CITY OF ALBUQUERQUE

Hydrology Section of the Planning Department

**Re: Picasso RV - 7800 Jacs Ln. NE
Grading & Drainage Plan Engineer's Stamp Dated 10/31/2017
(D16D002A6)**

<div>ENGINEER'S SEAL</div> <div></div> <div>10/31/17</div> <div>DAVID SOULE P.E. #14522</div>	PICASSO RV	DRAWN BY WCVJ
	GRADING AND DRAINAGE PLAN	DATE 10-30-17
	<div>Rio Grande Engineering 1606 CENTRAL AVENUE SE SUITE 201 ALBUQUERQUE, NM 87106 (505) 872-5999</div>	SHEET # —
		JOB # 21817

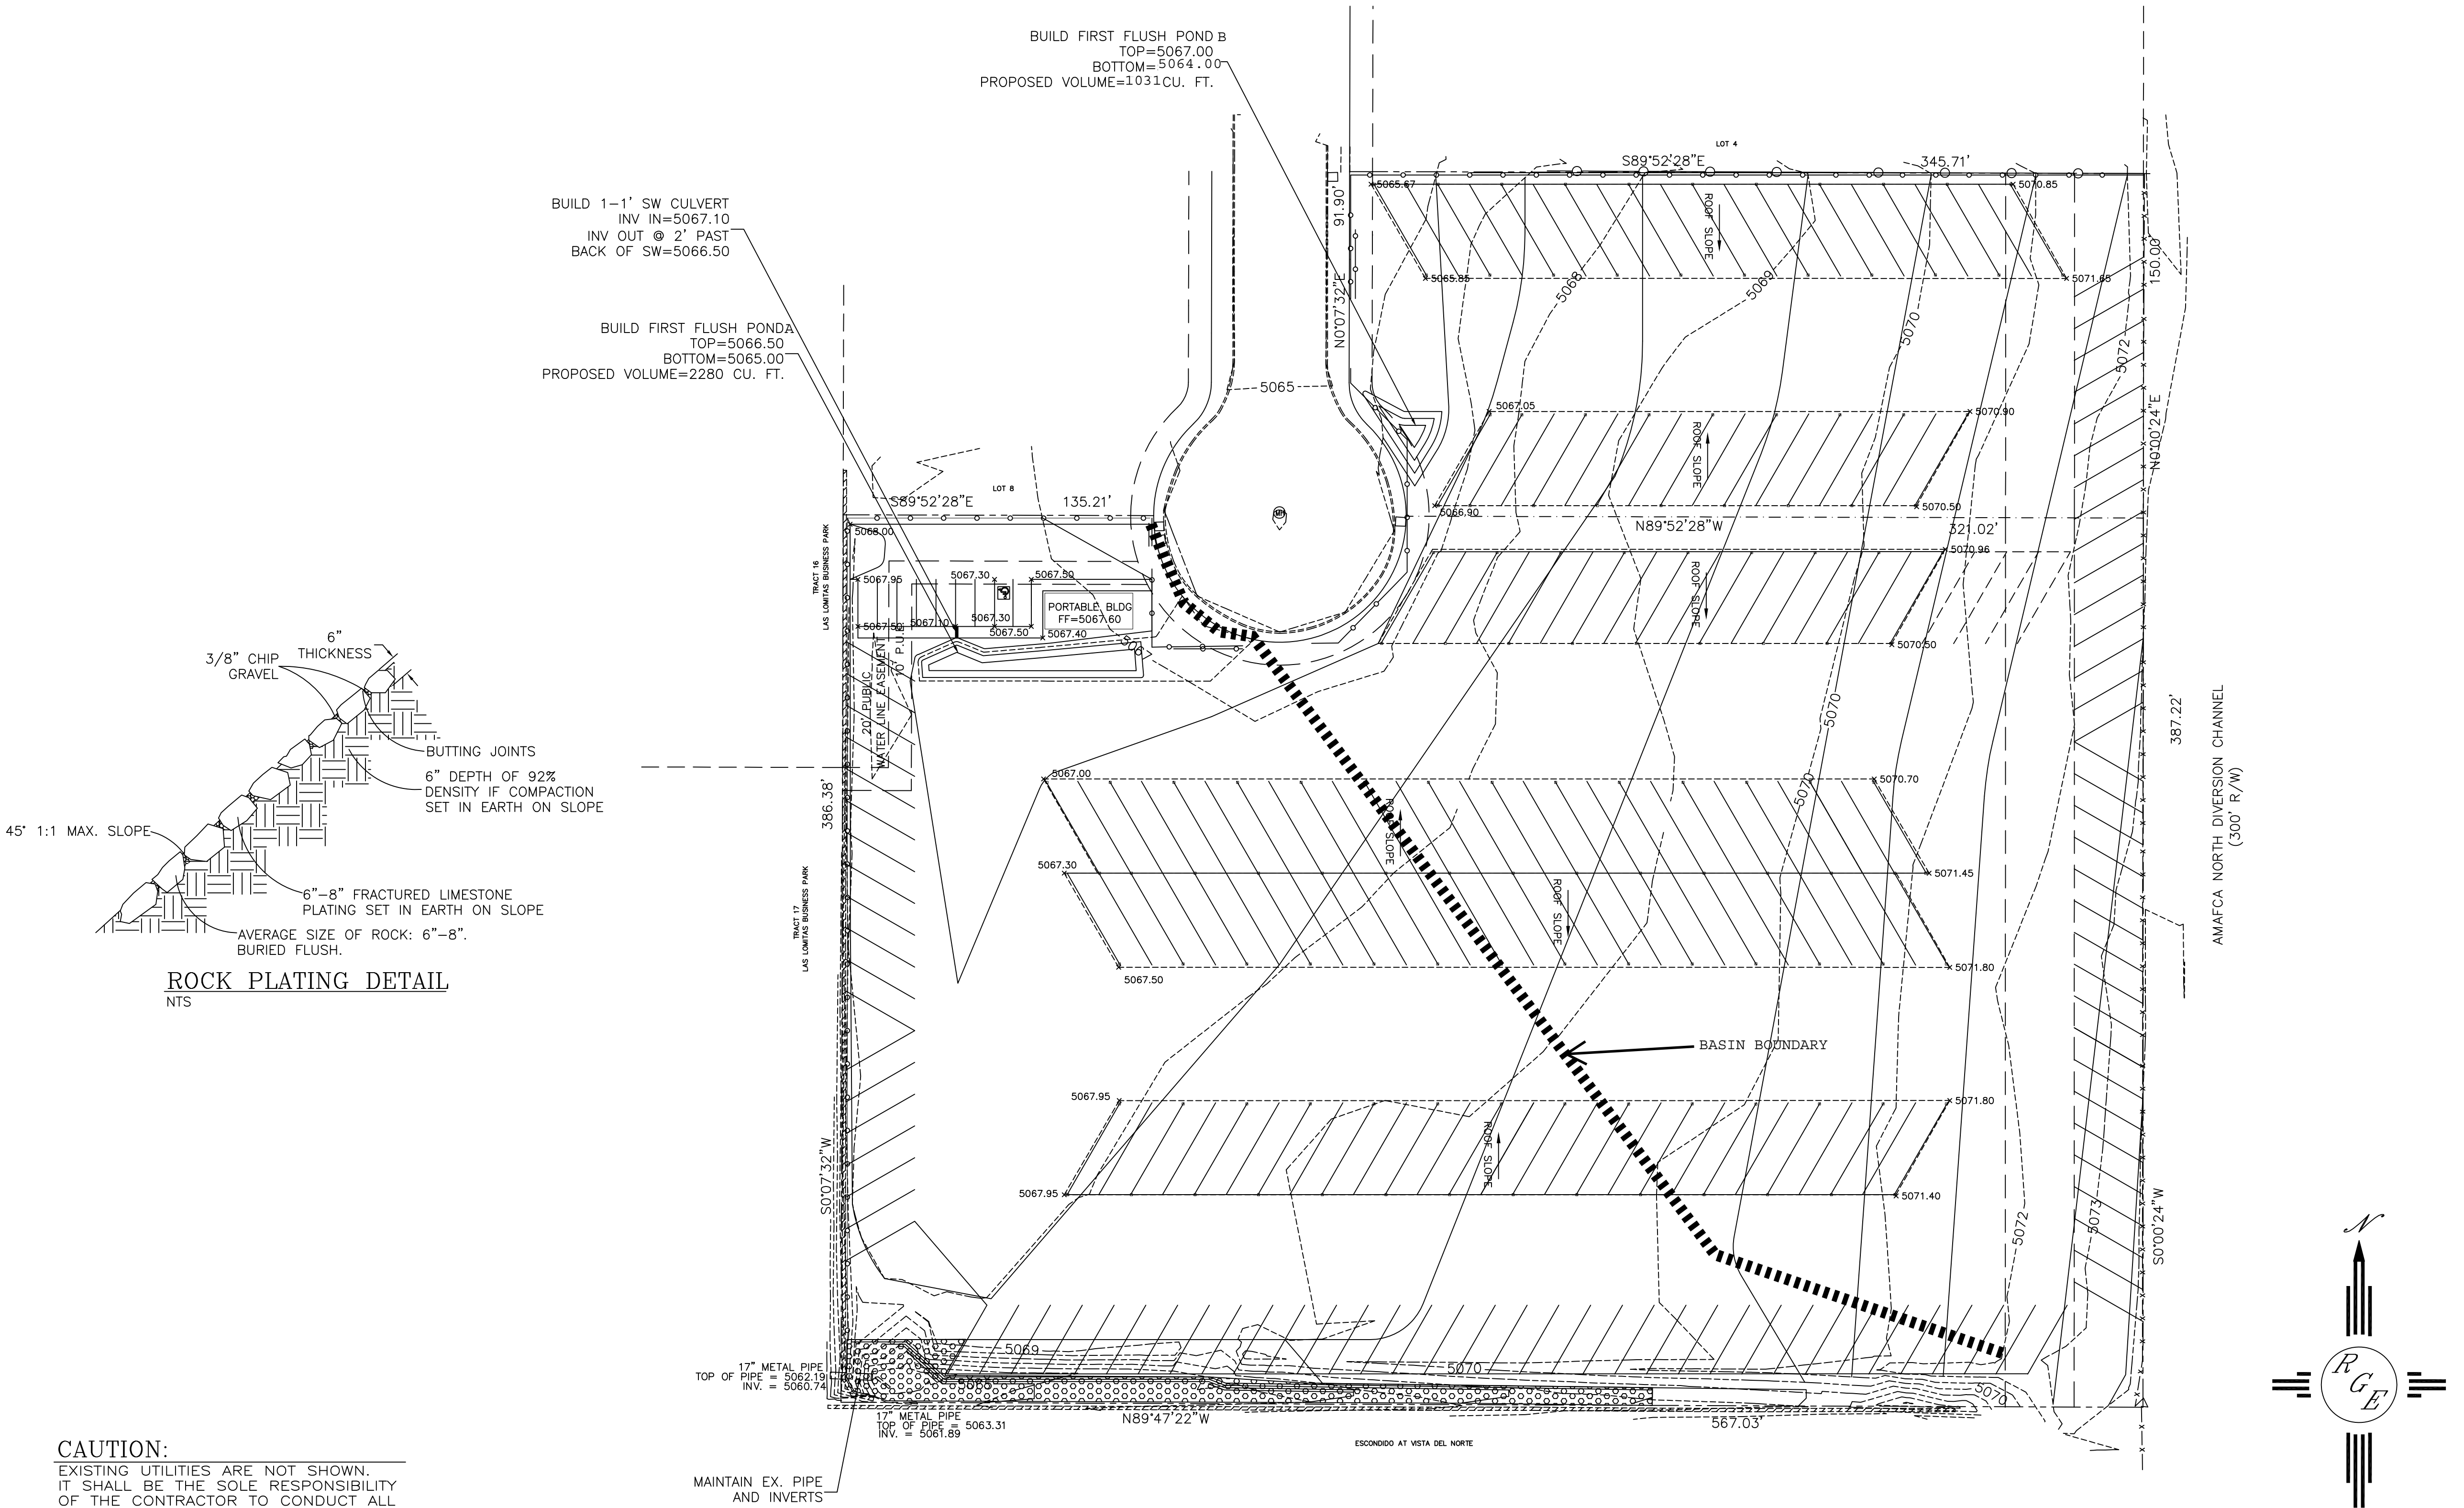
- Change the title of the sheet to be included in the Site Plan for Building Permit to Conceptual Grading and Drainage Plan and place a prominent label on the sheet "Not for Construction". A separate Grading and Drainage Plan for construction will contain additional details and must be submitted separately to the Hydrology Section of the Planning Department for approval of Grading Permit and Building Permit. The Building Permit Plans must include all sheets of the Site Plan for Building Permit and the Grading and Drainage Plan prior to Hydrology approval of the Building Permit.

- Add a reference to the Conceptual G&D Plan in a narrative description of the project stating that "The G&D plan for the Blue Sky Subdivision (drainage file D16D002) established Free Discharge as the drainage management plan for this property". Include notes in the narrative that identify the area of site, the area of land disturbance, and the area of paving/impervious surfaces and a description of how the first flush requirements will be met for this site.

- Existing topo and spot elevations on the adjacent properties must be added to the Conceptual G&D Plan with typical section on all sides of the property showing how the grading of this site will not encroach into any neighboring properties nor limit their use.

- Show all first flush calculations on the Conceptual G&D Plan. Provide calculations of the required first flush volumes for each pond and a table summarizing the area of each contour and the associated volume calculations for each one of the ponds. on the Conceptual G&D Plan.

- Show all hydrology calculations on the Conceptual G&D Plan, including the off-site drainage basin to the east. The portion of the right of way for the North Diversion Channel that currently drains thru this site must be shown on the Conceptual G&D Plan with topography and a basin boundary line. This site must

continue to accept the offsite drainage and include the flows in onsite hydraulic calculations.

- Clearly indicate building footprints, new paving, curb and gutter, sidewalks, driveways and limits of disturbance on the Conceptual G&D Plan. Line widths and types should be varied instead of being the same for all of these features. More symbols, hatch patterns, and line types need to be added to the legend.

- Sidewalk and driveway(s) are required in the public right of way along this property's frontage on Jacs Ln. and must be shown on all sheets of the Site Plan for Building Permit prior to DRB approval. A typical section showing the horizontal and vertical dimensions from the right of way line of Jacs Ln. to the curb and gutter, sidewalk, and onsite drainage swale must be shown on the Conceptual G&D Plan.

- Show all hydrology calculations on the Conceptual G&D Plan, including capacity of the onsite drainage swale next to Jacs Ln. and sidewalk culverts. Pond overflow spillways must be directed to sidewalk culverts having capacity for the 100-year peak flow rate that must be shown on the Conceptual G&D Plan with construction notes. Flows in excess of the first flush volume should not mix with the first flush volume, so the inlet and outlet to the pond should be close to each other.

- A note must be added to the Conceptual G&D Plan stating "An excavation permit will be required before beginning any work within City Right-Of-Way". If an infrastructure list is not required at DRB then the rest of the SO-19 notes should also be placed on the plan.

- Existing utilities and easements must be shown on the Conceptual G&D Plan along with a note that says "Two working days prior to any excavation, the contractor must contact New Mexico One Call, dial "811" [or (505) 260-1990] for the location of existing utilities. Prior to construction, the contractor shall excavate and verify the locations of all obstructions. Should a conflict exist, the contractor shall notify the engineer so that the conflict can be resolved with a minimum amount of delay." The utilities must be marked in the field and their surveyed locations must be shown on the Conceptual G&D Plan, especially in the existing 30' PNM Gas Pipeline and Communication easement on the east side of this property. Written coinsurance from PNM is required prior to DRB approval of the Site Plan for Building Permit and may take the form of an Encroachment Agreement.

- The existing AMAFCA Excavation Restriction Easement on the east side of the site must be shown on the Conceptual G&D Plan and AMAFCA approval of the plan is required prior to DRB approval of the Site Plan for Building Permit.
